CAPISTRANO UNIFIED SCHOOL DISTRICT BOARD REPORT

Board Item: Change Order No. 1, Bid No. 1819-17, Palisades Elementary School

Modernization Project

CHANGE ORDER

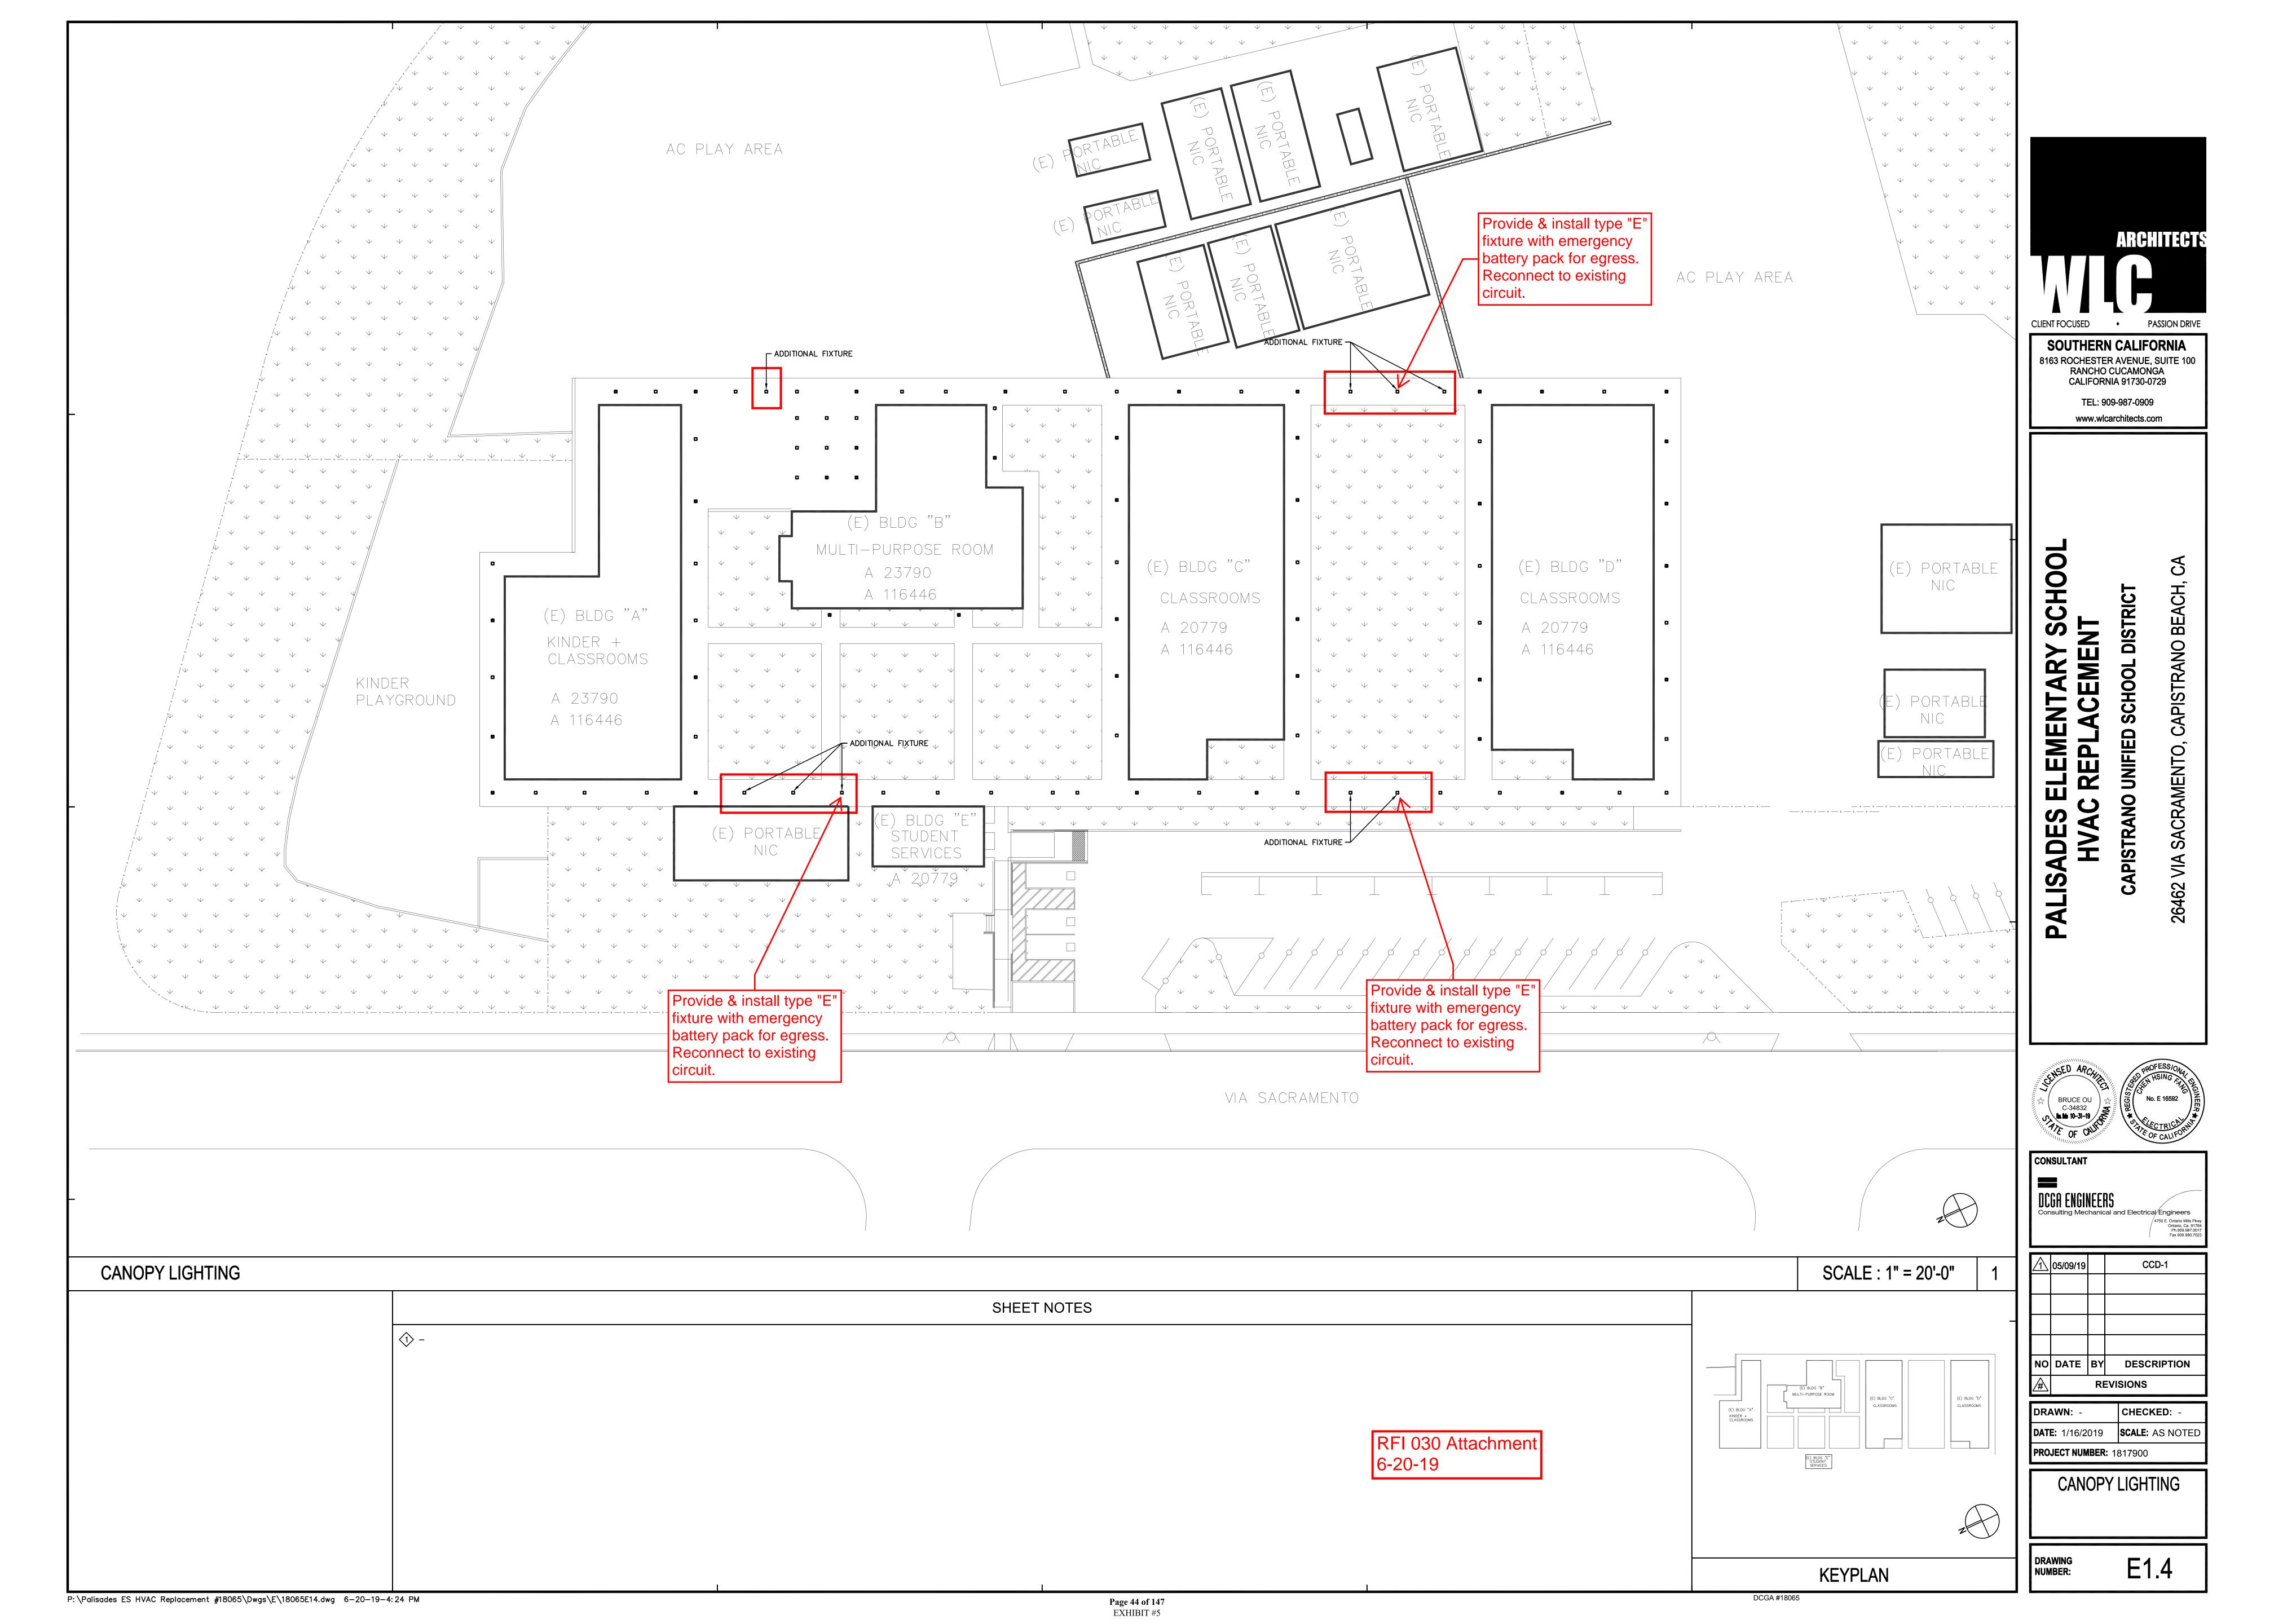
Our firm has counted and verified with the Architect that there are 12 more existing type E light fixtures on site than what are shown on the plans. Please mark on the plans which 12 light fixtures are going to be deleted. As the existing J box for what will be a deleted fixture must remain accessible due to the need to maintain the raceway pathway to the remaining fixtures a removal painted blank steel plate will be installed to cover the hole at the deleted fixture location to maintain the access to the wiring j box.

A Canopy Lighting Plan has been created to indicate all replacement type "E" light fixtures (normal & emergency) for coordination purposes that are currently shown on approved drawings. This drawing is being issued for reference only at this time. There are some small canopy sections that indicate additional (E) fixtures that will require replacement; these have been noted on the attached drawing. Only (9) existing fixture locations where able to be located vs (12) as indicated in the RFI.

AA4.1 BUILDING A CONST DEMOLITION ROOF PLANS Rev.0.pdf waste vents-gas line roof bldg A.pdf

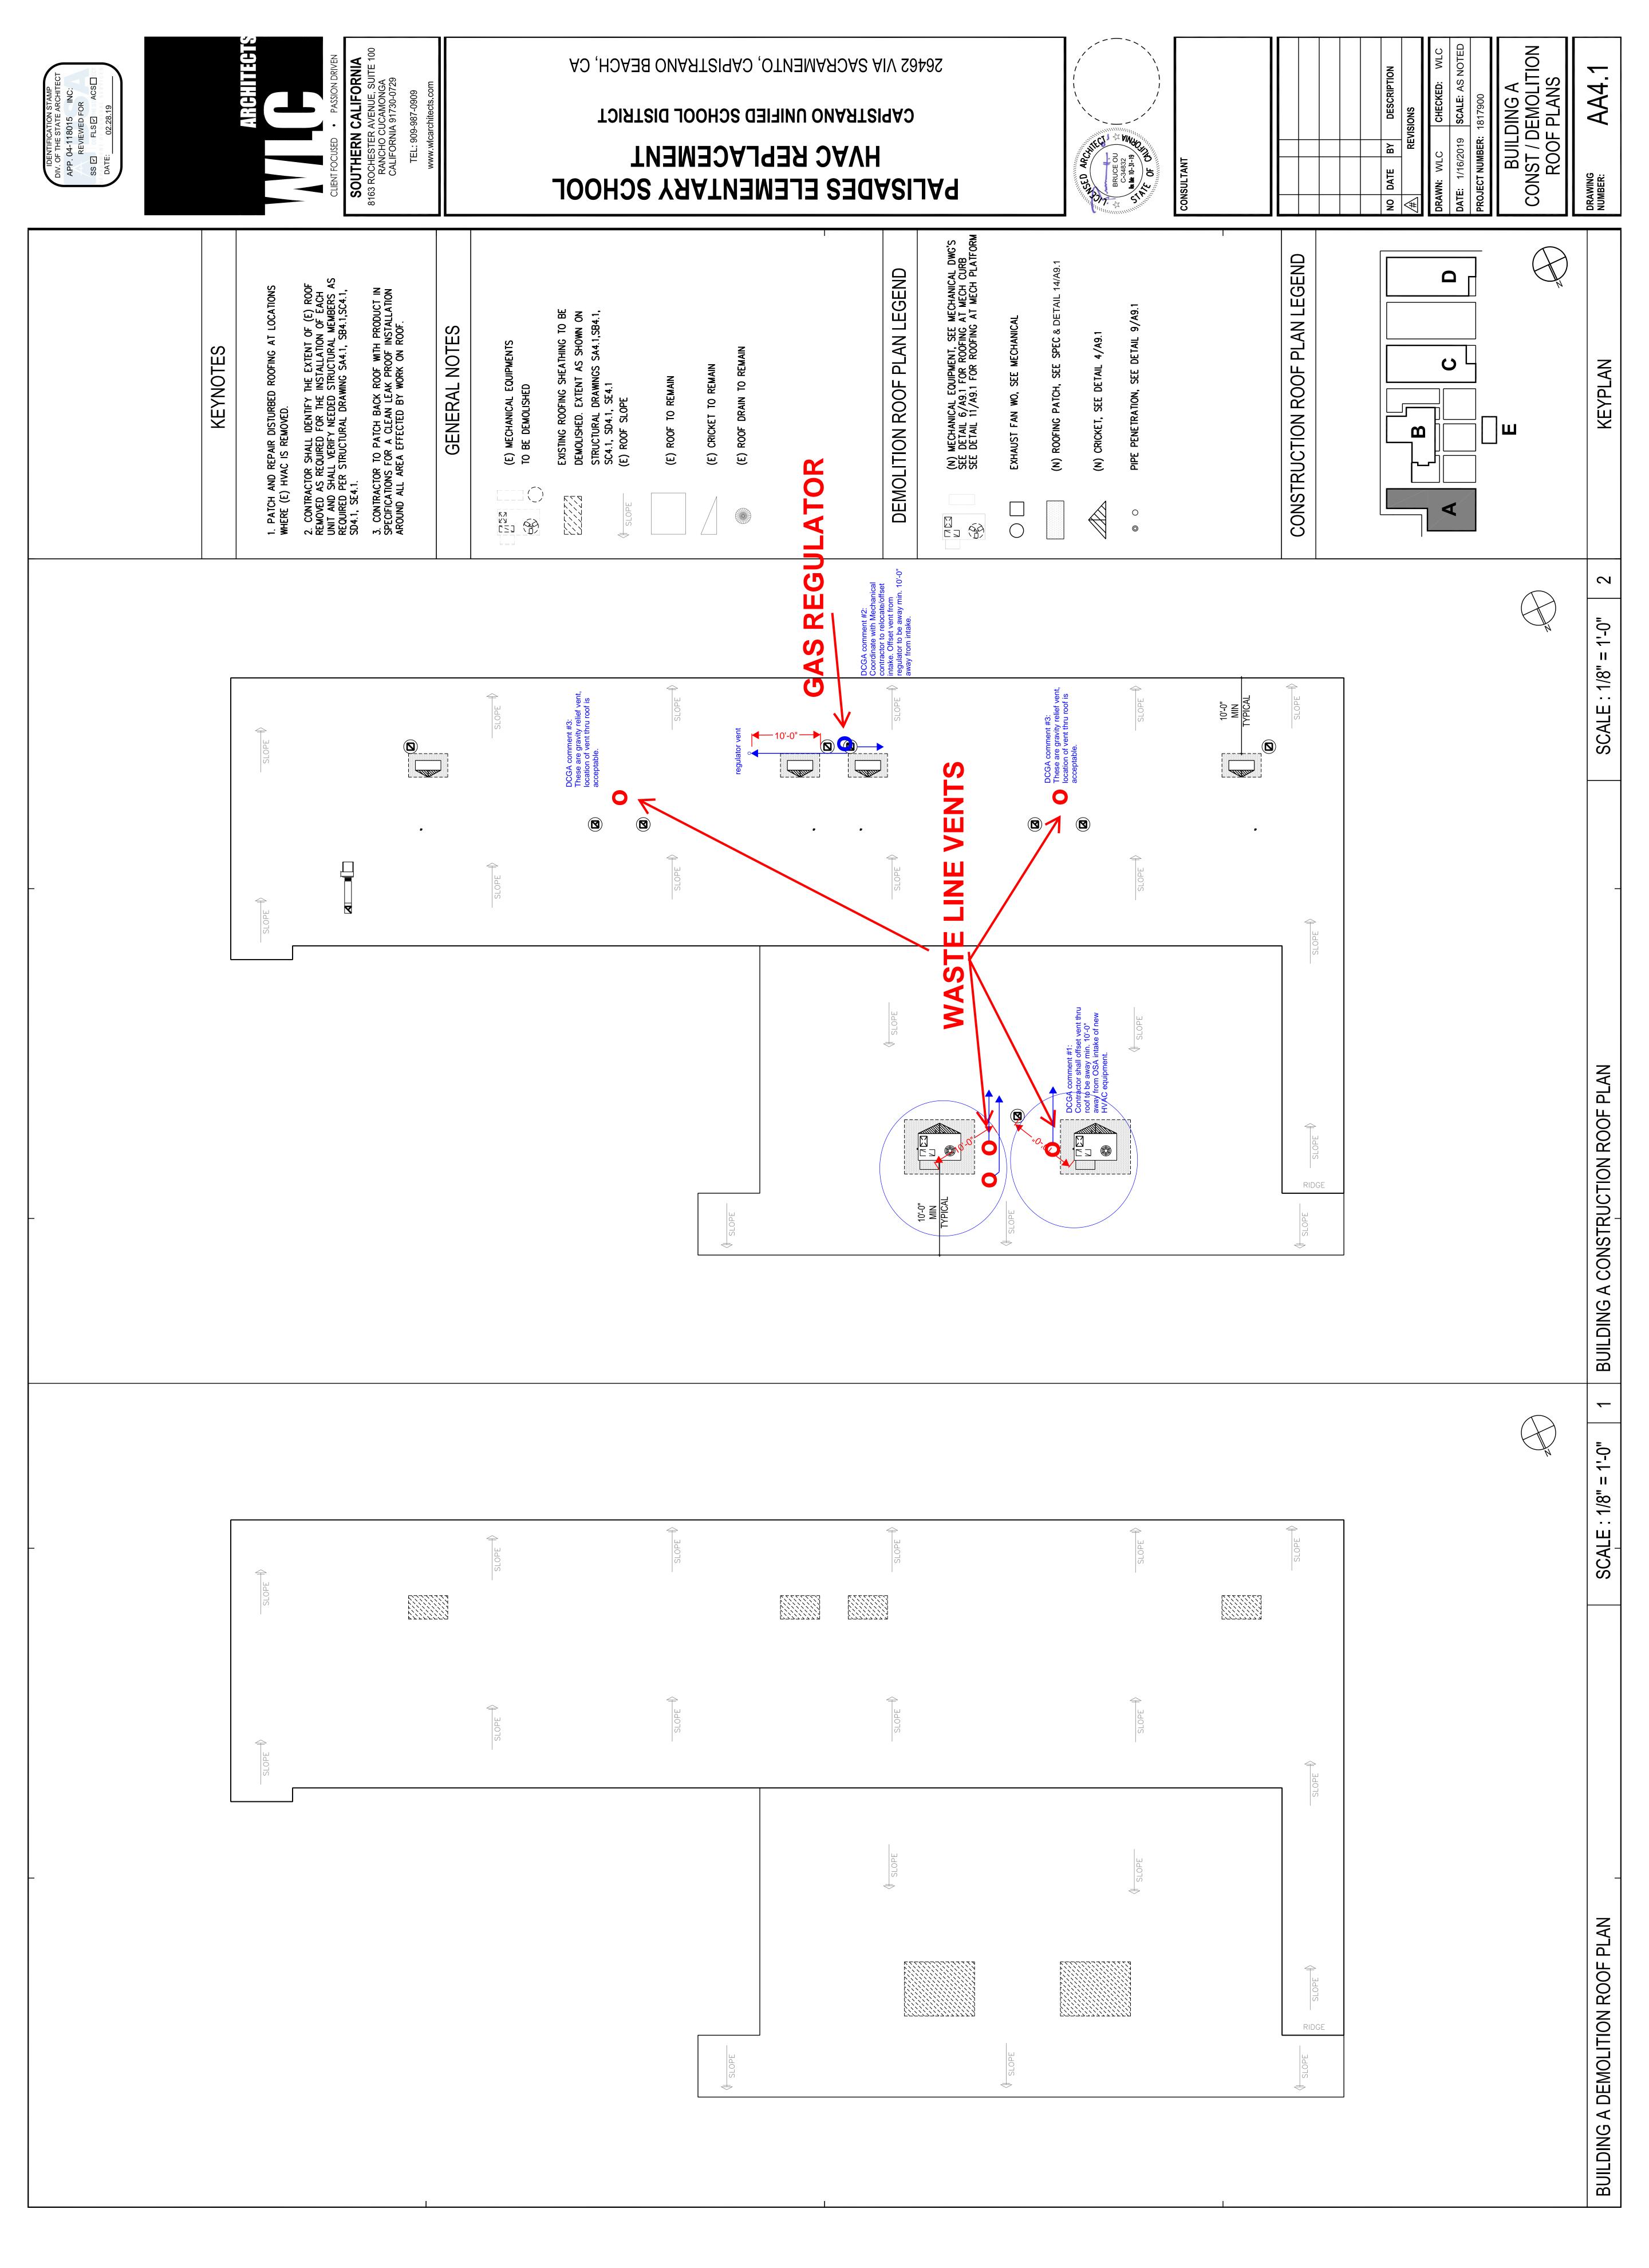
Following up our site meeting with AOR, please see attached roof plan showing the locations where the waste vents are too close to where new AC equipment has to be install, also photos for reference.
